Comal County Environmental Health

OSSF Inspection Sheet

Permit#: **118239**

Address: **424 VALLEY RDG**

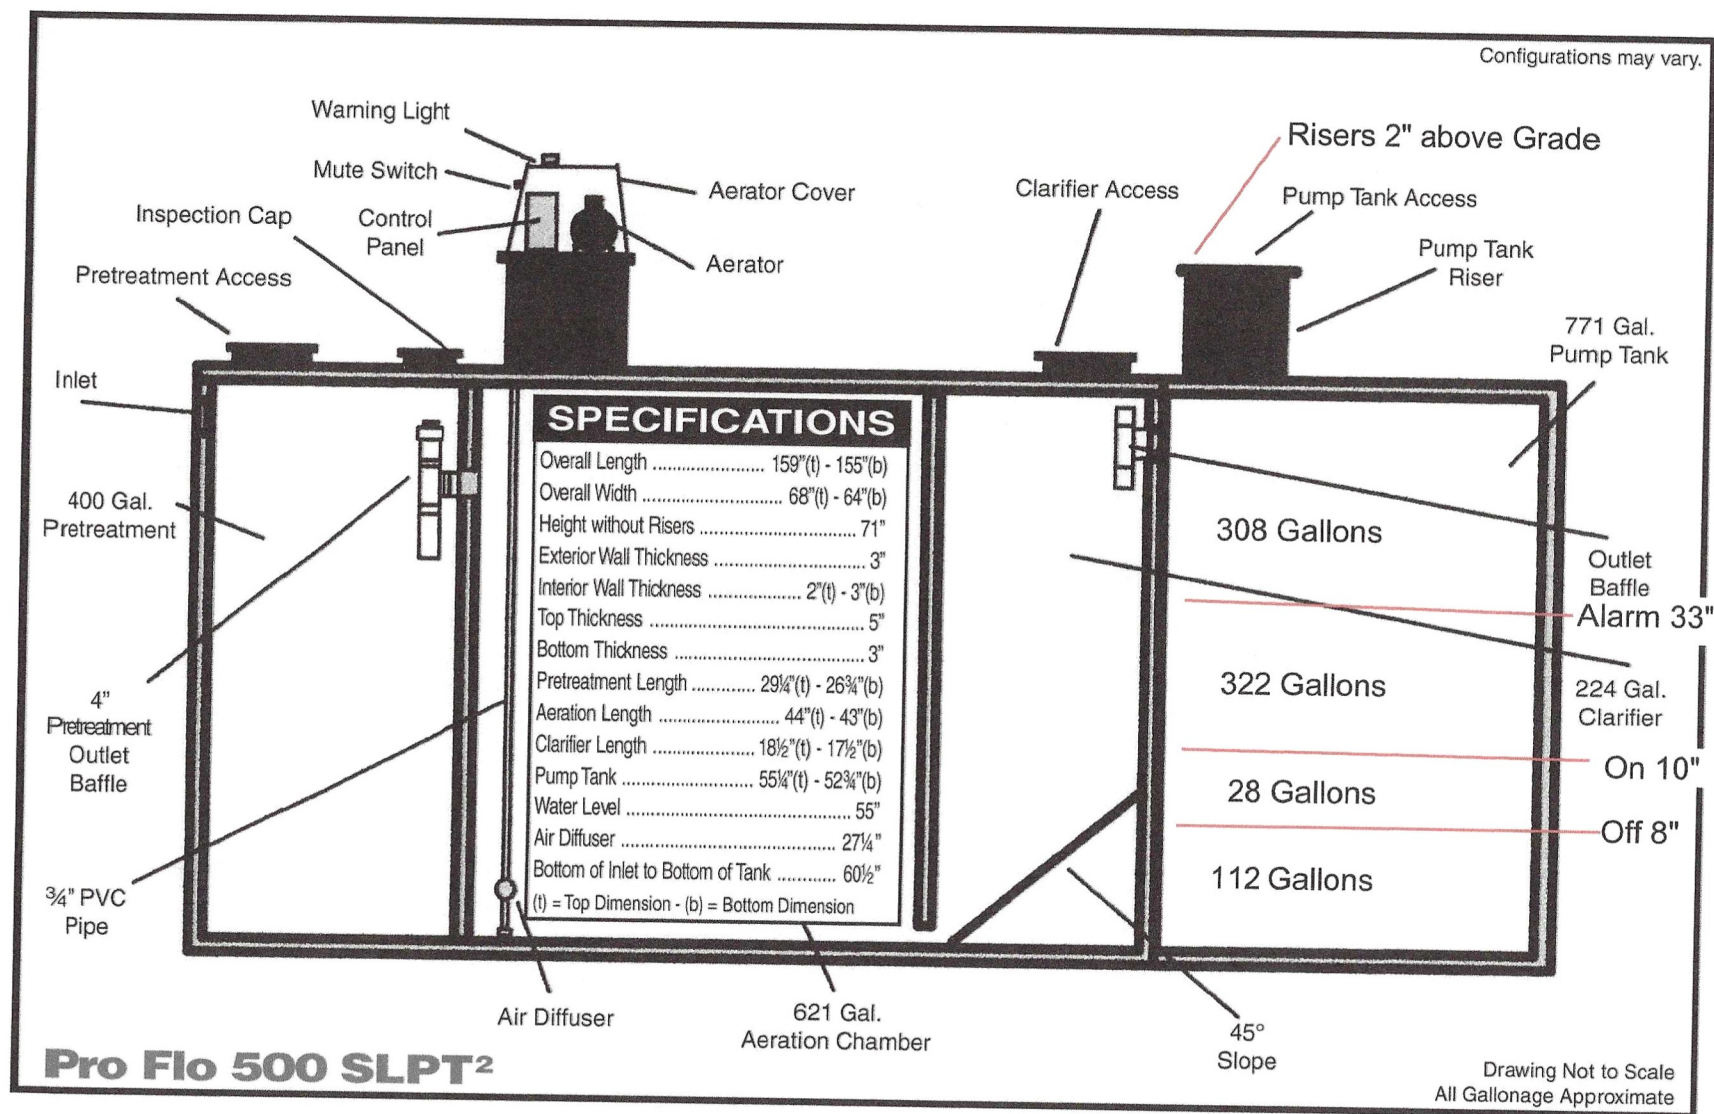
- 6) Identify the minimum 1 ft setback from the edge of the drip field to the utility easements.
[A 1 foot setback is now indicated.](#)
- 7) Revise as needed and resubmit.
